Form 504	
U. S. DEPARTMENT OF COMMERCE	
COAST AND GEODETIC SURVEY	
DESCRIPTIVE REPORT	
Type of Survey <u>SHORELINE (Photogrammetric)</u>	
Field No. ....	Office No. <u>T-11803</u>
LOCALITY	
State <u>Mississippi</u>	
General locality <u>Mississippi Sound</u>	
Locality <u>Bernard Bayou</u>	
<u>19 66 - 1967</u>	
CHIEF OF PARTY	
<u>J. Bull, Director, Atlantic Marine Center</u>	
LIBRARY & ARCHIVES	
DATE .....

T - 11803

JOB PH-6625  
MISSISSIPPI SOUND  
MISS.  
SHORELINE MAPPING  
1:10,000 SCALE

REVIEW REPORT T-11803  
SHORELINE  
July 1968

△ GULFPORT MUNICIPAL WATER TANK 1958  
Steel ht = 176 (199)

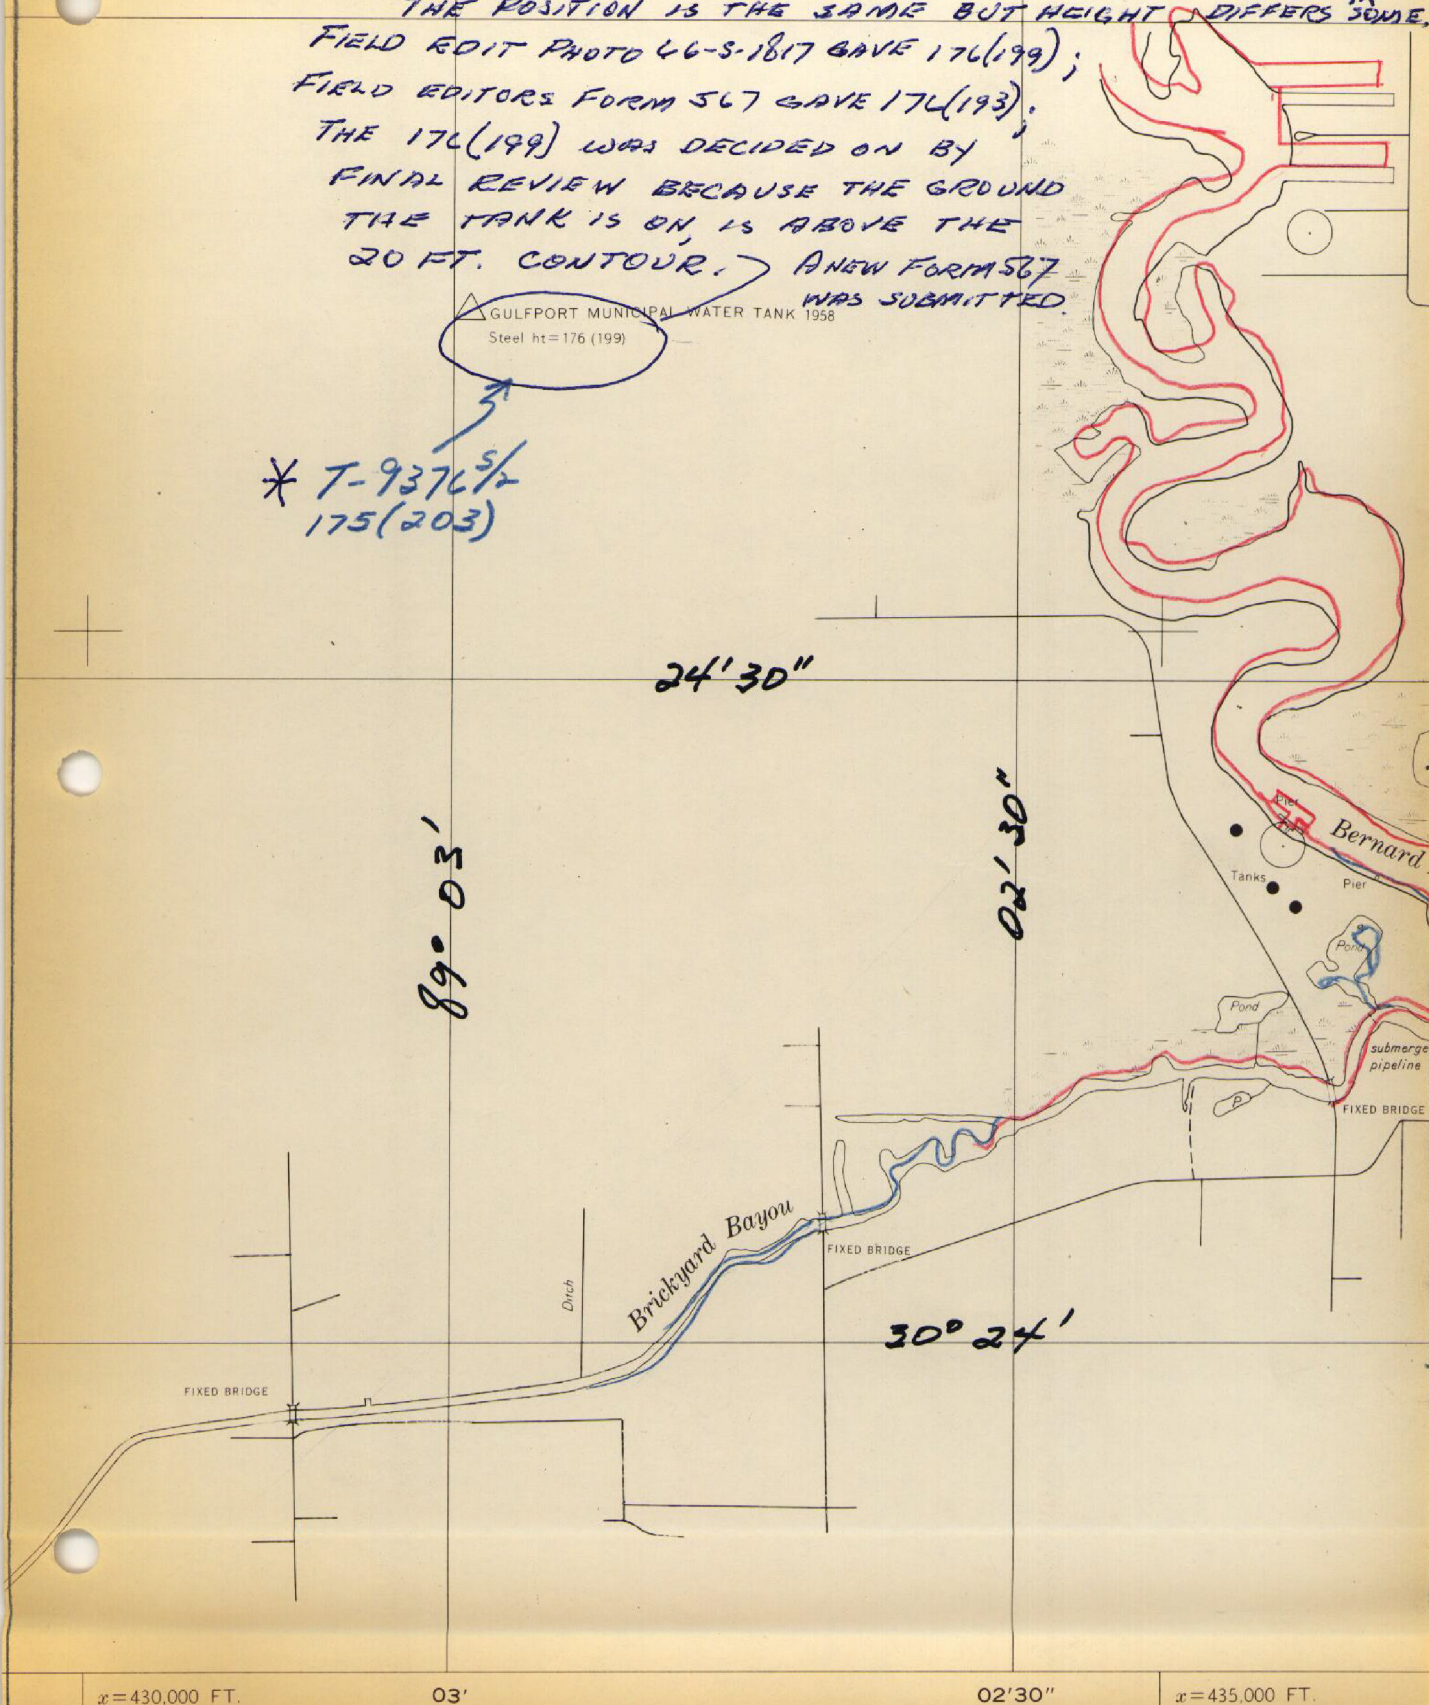
(a) T-11803 shows the height and elevation of Gulfport Mun. Water Tank 1958 as 176 (199), page 24, whereas T-9376<sup>S</sup>/2 shows it as 175 (204). It is noted that the field editor for T-11803 gave the 176 (199) on field edit photo 66-S-1817, but submitted a Form 567 with "176 (193)". The 176 (199) is used because the tank is located on land that is beyond the 20 ft. contour according to T-9376<sup>S</sup>/2.

THIS IS SAME TANK THAT WAS "PORT 1951"  
AS TOPO STATION.

THE POSITION IS THE SAME BUT HEIGHT DIFFERS SOME.  
FIELD EDIT PHOTO 46-S-1817 GAVE 176(199);  
FIELD EDITORS FORM 567 GAVE 174(193);  
THE 176(199) WAS DECIDED ON BY  
FINAL REVIEW BECAUSE THE GROUND  
THE TANK IS ON, IS ABOVE THE  
20 FT. CONTOUR. A NEW FORM 567  
WAS SUBMITTED.

UNAVAILABLE & CHANGE  
FENCILLED ON BOAT  
SHEET H 8923 BY  
HYDROGRAPHER

REVISED DURING  
FINAL REVIEW  
TO THIS
